EAST ROSWELL LIBRARY
ADDENDUM NO. 02.1-2
APRIL 22, 2013

This Addendum No. 02.1-2 dated April 22, 2013 issued by Ajax Building Corporation of Georgia is hereby made part of Bid Package 02.1 – SITEWORK & UTILITIES for the East Roswell Library. The changes and/or clarifications included in this Addendum shall be considered as part of the Bidding Documents and shall supersede, amend, add to, or subtract from those conditions included in the original Bidding Documents, including the Project Bid Package, Drawings, Specifications, previous Addenda, etc. This Addendum must be acknowledged in the space provided on the Proposal Form (included in Section II of the Bid Package). Failure to acknowledge this Addendum may subject Bidder to disqualification.

East Roswell Library

ADDENDUM NUMBER ONE

UTILITY PLAN

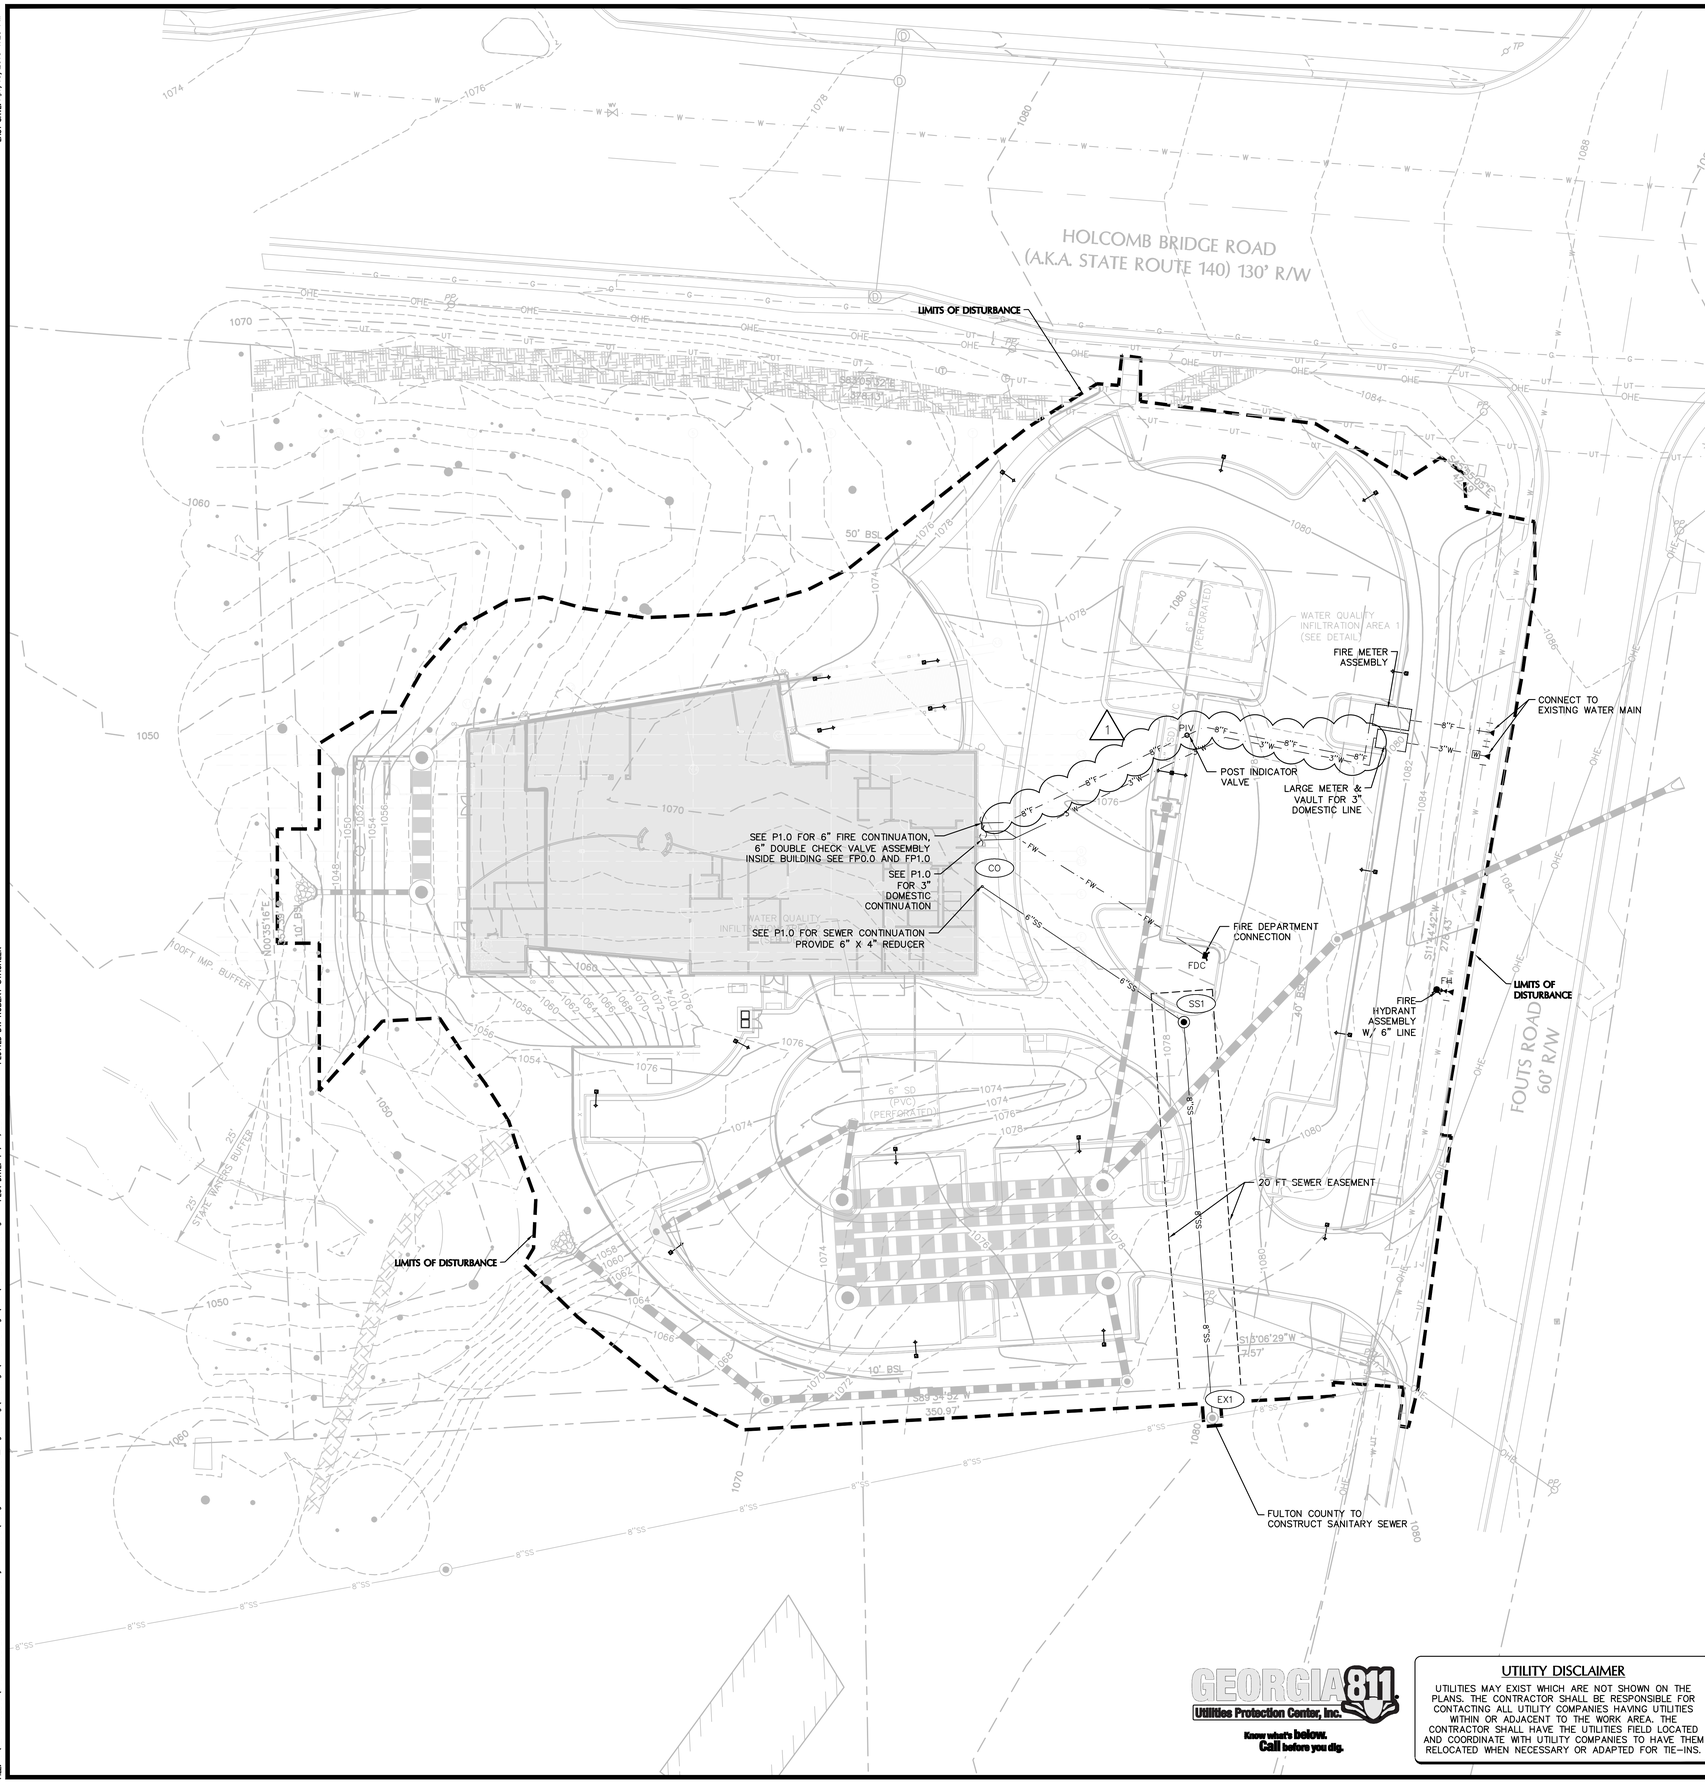
1. The following sheets are issued herewith:
   a. C-500 Utility: delete the sheet and replace with the attached sheet. The fire line between the fire meter assembly and the building has been upsized from a 6-inch line to an 8-inch line.
   b. FP0-0 - Fire Protection Legend, Schedule and Details: delete the sheet and replace with the attached sheet. Detail 4 – Added a 6" tag to the outgoing line on the Double Check Valve Assemblies Detail, DCVA, and changed the incoming fire line size from 6" to 8" on the same detail.

1 BASEMENT FLOOR PLAN - FIRE PROTECTION
1/8" = 1'-0"

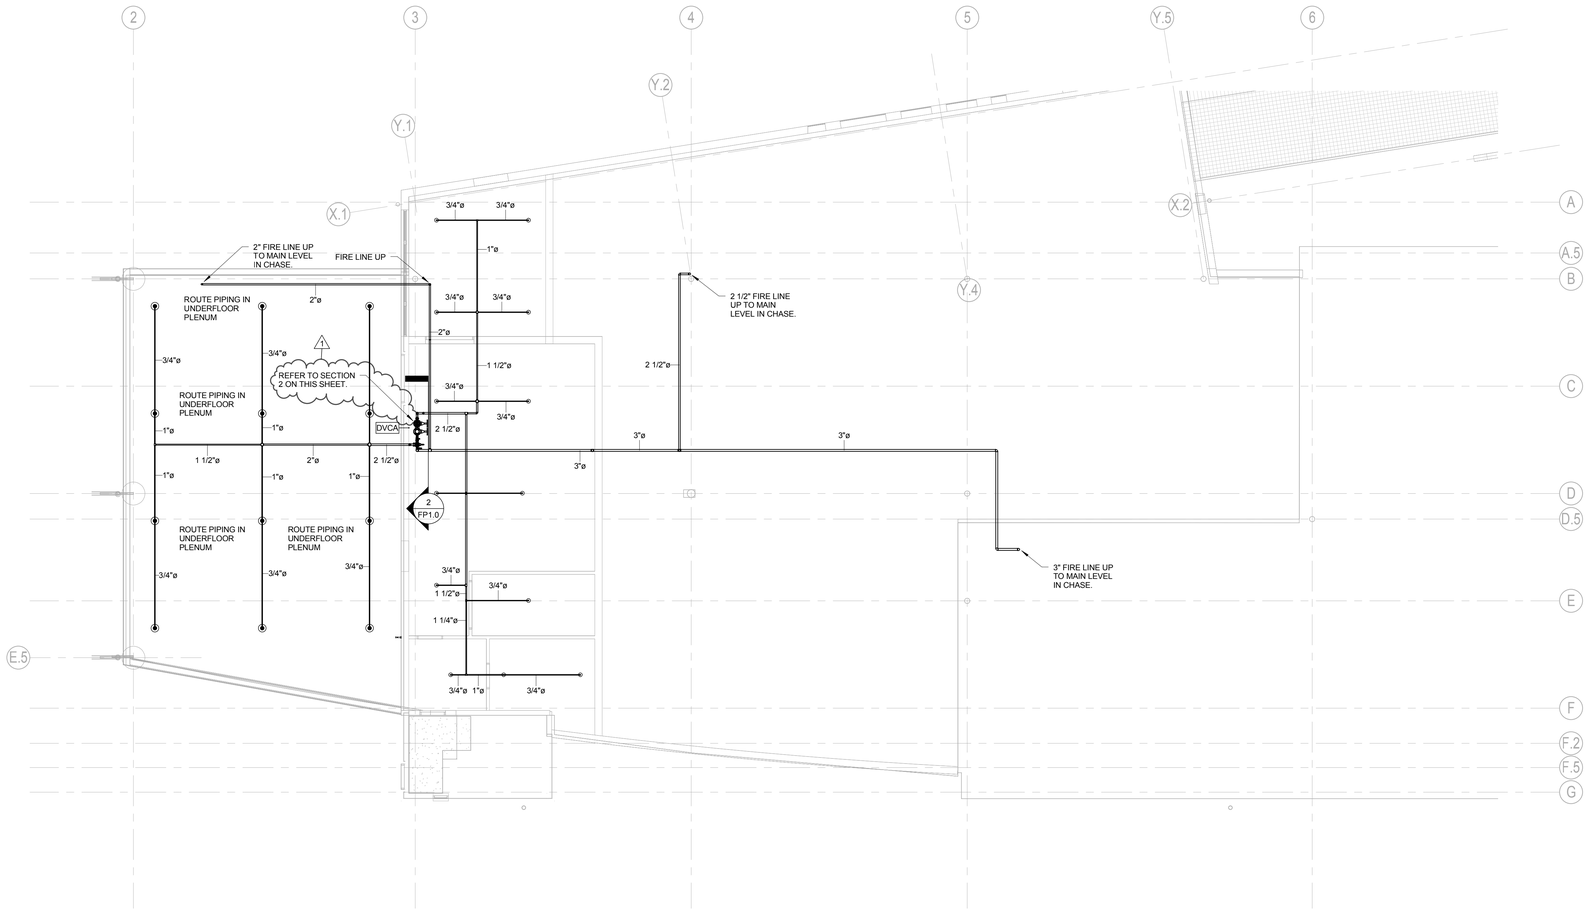
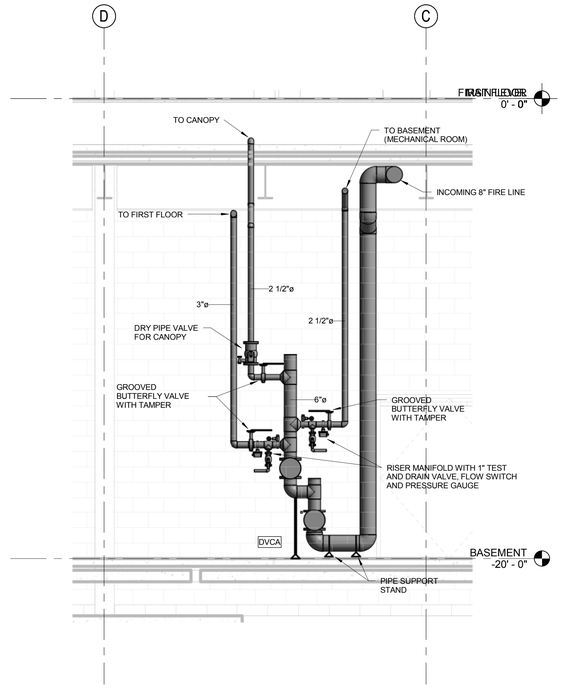
c. FP1-0 - Basement Floor Plan - Fire Protection: delete the sheet and replace with the attached sheet. Plan - Changed the note pointing to the DCVA to read as follows: "Refer to Section 2 This Sheet."
